# Washington State Convention Center Addition Project

### **Downtown Design Review Board Meeting**

Early Design Guidance #3

16 4 response to comments

ROOF PLAN

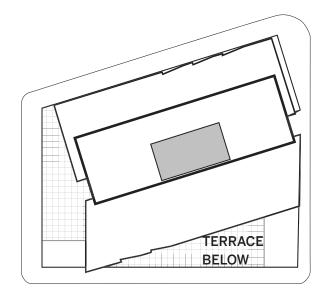
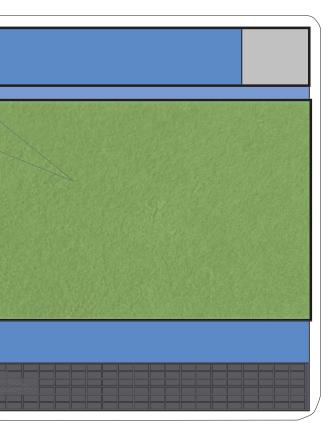
6f: CCX Roofscape Plan: a complete landscape design, preferably with some usable space and public access, should be provided at the next meeting.

#### STORMWATER MANAGEMENT & HABITAT

SOLAR ENERGY COLLECTION

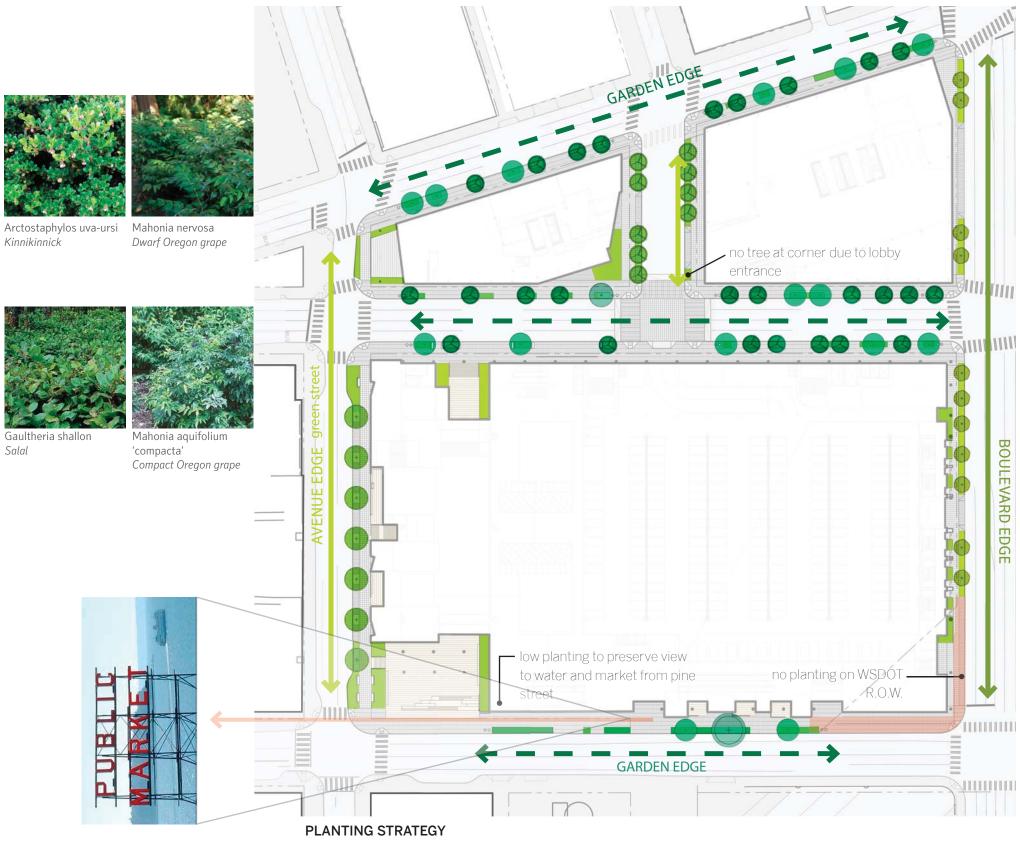
6f: CCX Roofscape Plan: a complete landscape design, preferably with some usable space and public access, should be provided at the next meeting.

Planting is used throughout the site to define edges and characterize different zones of the project. The Boulevard Edge defines the most formal approach utilizing consistent and regular planting areas and species. The Avenue Edge is similar in approach, but at a grander civic scale with more flexibility and variety to accommodate large groups of people. The Garden Edge concept applies to the east-west streets, the most casual in texture and variety to navigate the typically sloping streets towards the waterfront and promote greater visual interest along the longer frontages and define areas of activity. Street trees fill the edges of the site to the extent feasible, with one notable exception - framing the incredible view to the waterfront along Pine Street, showcasing Pike Place Market and the Paramount Theatre.

PLAN OF COMMERCIAL BUILDING

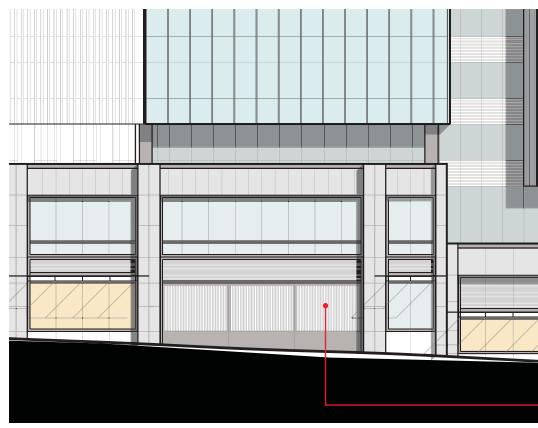
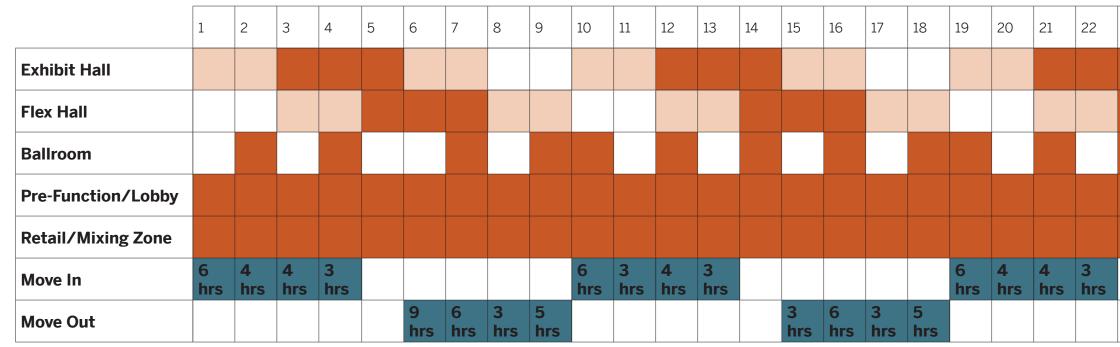
6c: Truck Operations: the quantity, duration and daily timings of truck movements on the Terry plaza, and more detailed information on those operations.

The design concept for Terry Avenue has evolved to function as a familiar street pattern for pedestrians and vehicles, providing clarity to circulation patterns and continuity of the green street concept through the site. The massing of the building shifts the focus towards 9th Avenue to connect the green street couplet. The updated proposal notably includes reduced truck portal width from 3 to 2 bays coordinated with sidewalk designs to mitigate pedestrian/vehicular conflicts. Sliding screening allows the portal to be fully or partially closed to reduce over all width when not needed for heavy loading. Increased landscape screening promotes a stronger continuity of the pedestrian environment.

The facilities is designed to allow multiple simultaneous activities in the building including move in / move out and event days. The following prototypical monthly schedule illustrates the type of activity pattern and event and loading intensity anticipated for a heavy activity month. There are between one to four active events in various parts of the facility almost every day. Beyond supporting scheduled events, approximately 300-1200 employees work in the facility each day. This illustration represents an order of magnitude of total daytime activity between the 14 hours of 6am and 8pm. Move In and Move Out activity represents truck volumes typical of heavy and medium freight exhibitions. The number of hours experiencing intense truck use (more than 5 trucks per hour or 1 truck approximately every 12 minutes) was tabulated over the course of the prototypical monthly event schedule.

HOWELL ST ELEVATION AND PLAN

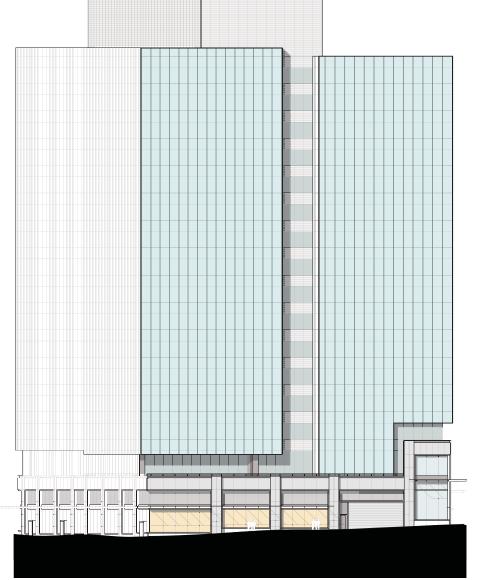
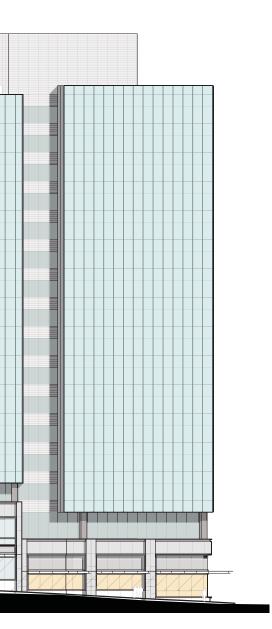
7f: Howell Street: screening of the truck ramp portion in the middle of block C must be sophisticated and provide excellent pedestrian interest.

The design of the Howell Street facade establishes a rhythm of pronounced solid frames with a transparent infill glazing system at the pedestrian level. The proposal continues the pattern of pedestrian scaled street frontages throughout the loading and service areas to promote continuity in the pedestrian experience, transparency to the functions beyond, and longterm flexibility to provide longevity to the building facade.

The screening strategy is to promote transparency into the loading areas beyond, and provide access to daylight and views of the functional activities within the building. The use of consistent storefront infill with vision glass provide continuity of the building facade and visual interest for pedestrians at street level.

BOREN AVE FACADE SECTION

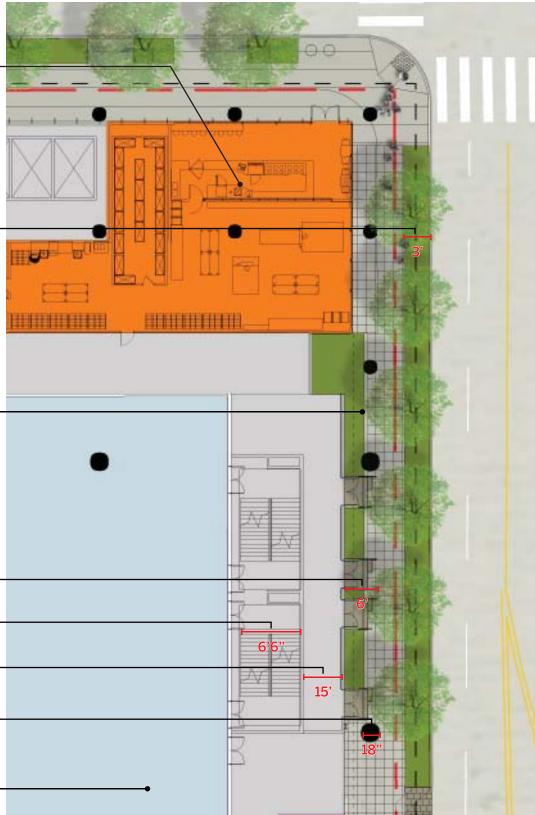
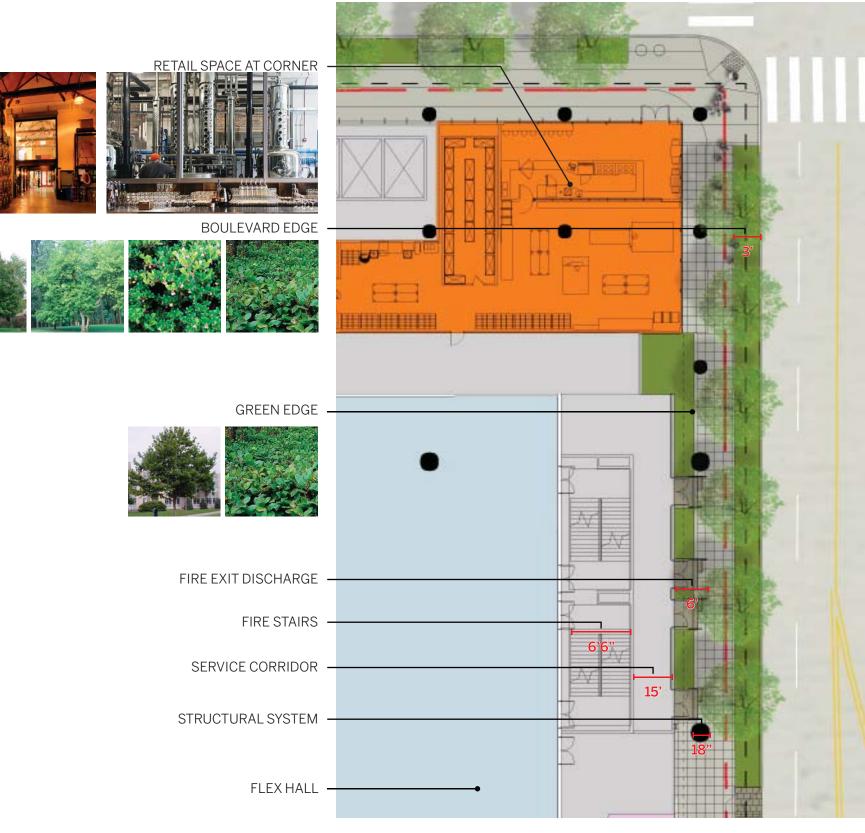
7c: Boren Avenue: recommended shallow 'pop-up' retail here rather than on Pine, or at a minimum, a continuous layer for display windows, artful wall treatments, and narrow landscape planters at the building edge. Large scale, detailed elevations are needed at the next meeting.

The development of the design has incorporated depth, layering, and intermediate scaling elements along the Boren Avenue façade. Regular areas for the possible incorporation of art and other facade treatments has been accommodated into the façade. Continuous green edge on both sides has been maximized to the extent possible to promote both safe visibility and a comfortable environment for pedestrians along this active roadway.

**PREVIOUS** PROPOSED DESIGN PERSPECTIVE- BOREN AVE

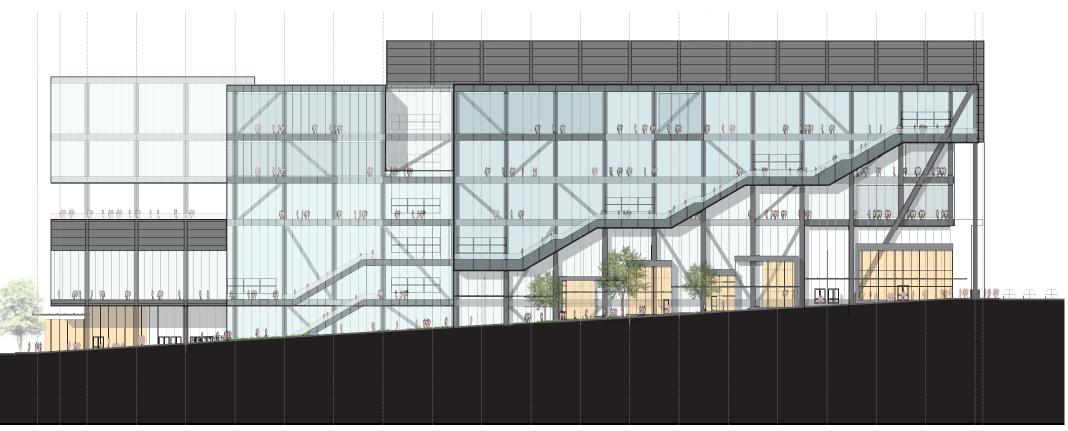
5f: East Corners: both east corner points remain weak; the retail should be larger and have more vertical presence relative to the tall mass above.

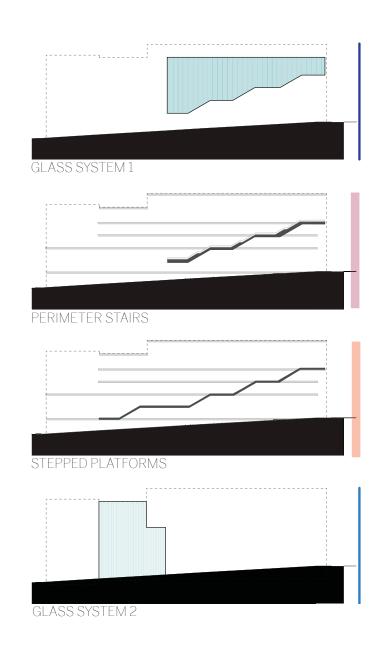
6a: Pine Street Elevation: The specific materiality of this south-facing glass volume should be explained in detail at the next meeting, in terms of reflectivity, glass patterns/color, energy performance and shading.

See diagram below for explanation of facade modulation, layering and materiality.

The sloping soffit below the perimeter stair will be a promenent architectural feature. It offers the opportunity for special lighting, artwork and special materials such as a mirrored surface. **RETAIL PLANS & ELEVATION**

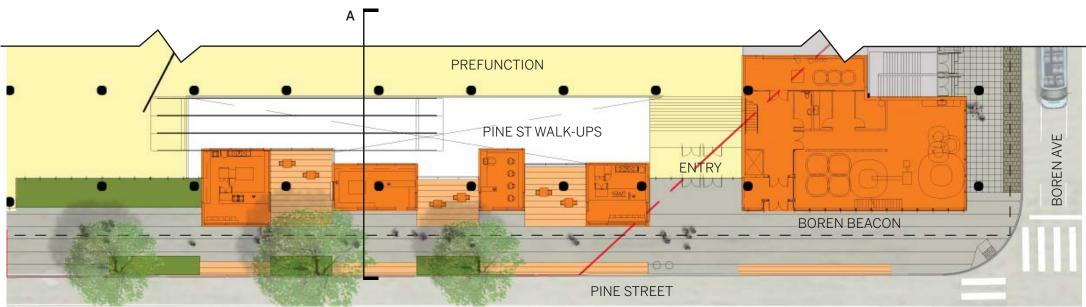
7b: Pine Street: recommended more retail depth (where customers enter the space) and more linear retail frontage in the middle and west block face, well beyond the approximately 25% shown; the pre-function atrium should possibly be narrowed to afford more retail depth, at least at sidewalk levels.

The retail concept considers the large double block of Site A and breaks down the scale into familiar pattern of whole block zones and sub-elements, including retail, landscape, and pedestrian access points. The concept along the large zone of Pine Street is to extend the eclectic small scale texture and variety of Capitol Hill across the freeway, balancing a large signature corner retail beacon with a combination of convenient walk up services to serve both pedestrians on their way to/from Capitol Hill, as well as convention delegates. The retail is punctuated with landscape planting and platforms, providing casual places to pause, observe and linger along the incline of Pine Street.

9TH AVE PLAN OF MIXING ZONE

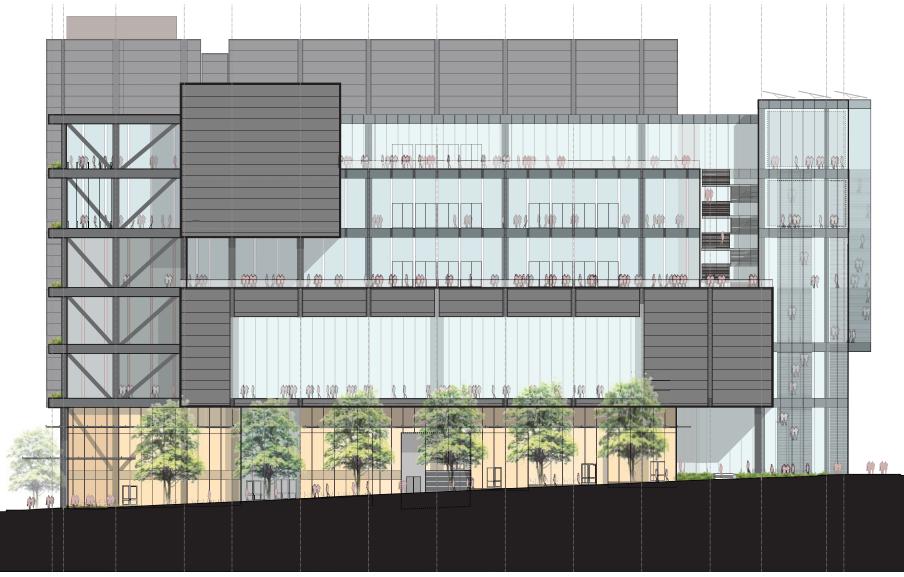
7a: 9th Avenue: recommended more depth for the street facing portions of the split level retail (pg 66 shows 12 ft) to ensure this critical Green Street frontage is successful and lively.

#### PLAZA SECTION

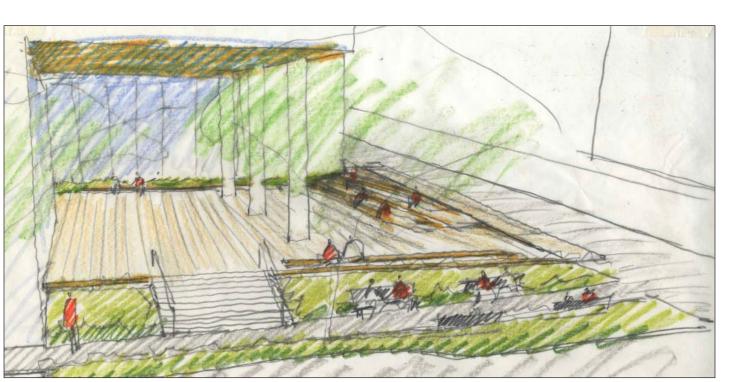
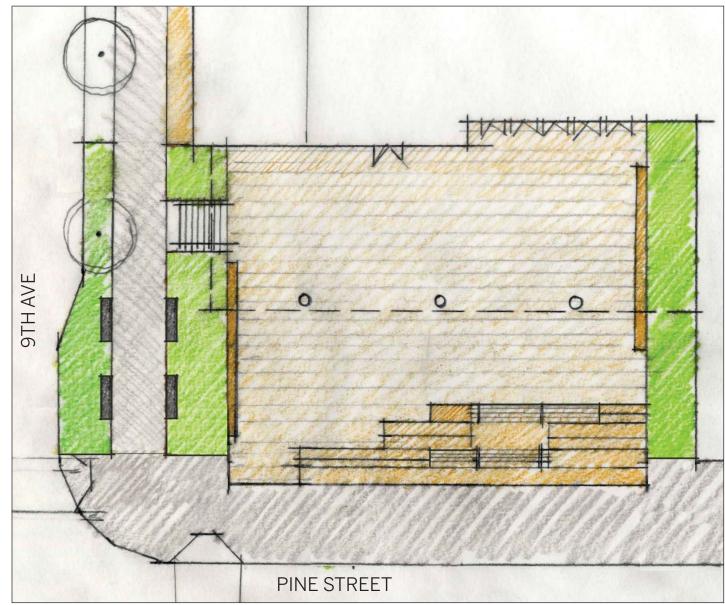
6d: Southwest Plaza: recommended the two open sides slope or step with the adjacent sidewalks to maximize pedestrian access and diagonal desire lines, and add retail activation at the southeast corner of this plaza.

**PREVIOUS** PERSPECTIVE AT INTERSECTION

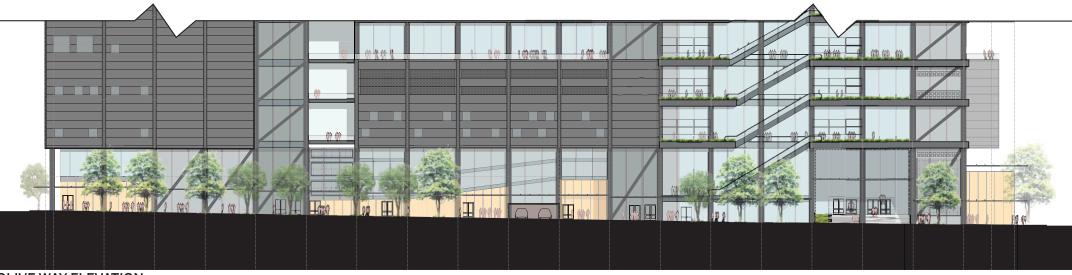
7e: Olive Way - West End: recommended replacing the employee and parking entries with retail, or a prominent and gracious forecourt/entry that leads Green Street pedestrians west to the stairs/escalators at the north end of the 'mixing zone' (see comment 6d).

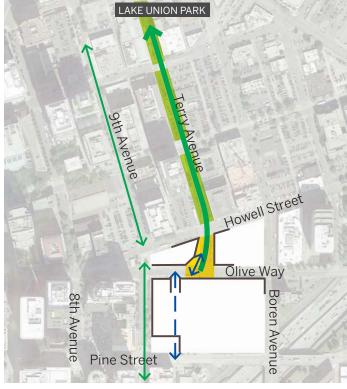
7e: Terry Avenue Terminus: the parking portal should be shifted, or further façade and scale techniques must be developed to mitigate the portal presence, yet provide a suitably scaled visual terminus.

The loading access has been developed to minimize the visual impact of garage entries and provide significant street level uses and lobbies along the frontages, concentrated at all corners. The remaining loading areas will be provide visual interest with screening integrated into the street level façade rhythm and materially to create continuity of the pedestrian experience at street level.

#### **TERRY AVE SECTION A**

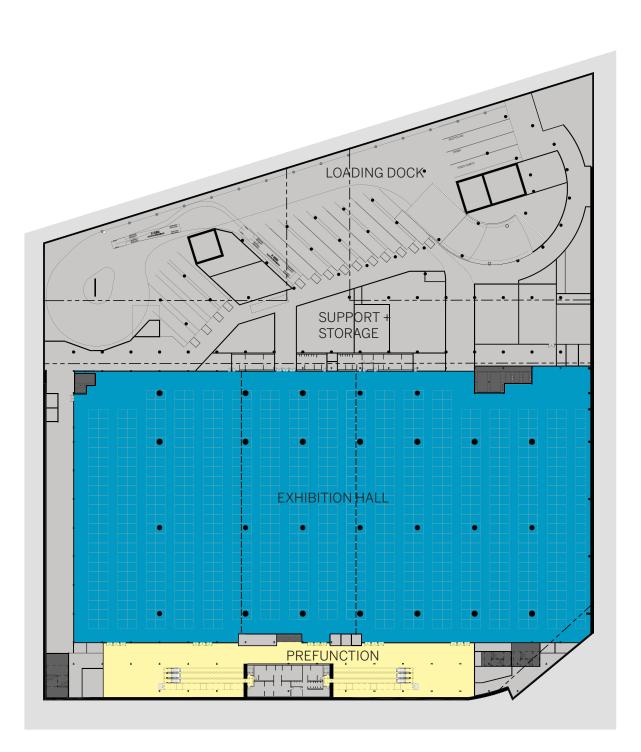
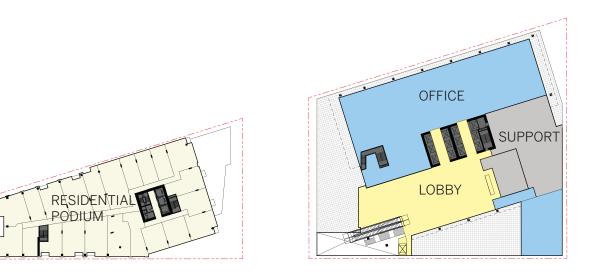
5c: Terry Avenue Frontages: adjacent building walls must be fully composed; the street-level image on pg 47 presented many concerns about large, blank ground level loading doors.
